## New OptiMax Cowl Seal

250XS and 225 Sport XS (2006 Model Year and Up)

17724

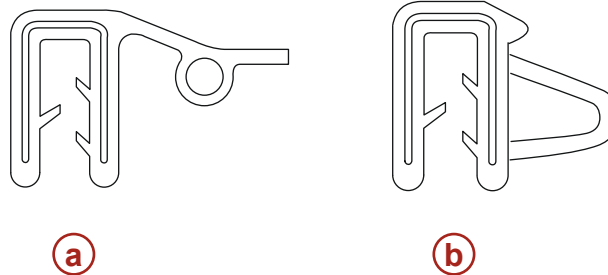
The new seal may initially make top cowl installation difficult. However, the seal will eventually take a set shape, making cowl installation easier. If you are experiencing difficulty installing the top cowl, lubricate the seal with a spray-on silicone lubricant (obtained locally).

**a** - New cowl seal (844155-001)

**b** - Standard cowl seal

This seal is available through Mercury Precision Parts and can be retrofitted to older models. To install the seal on the lower cowls, lubricate the inside edges of the seal with a spray-on silicone lubricant.
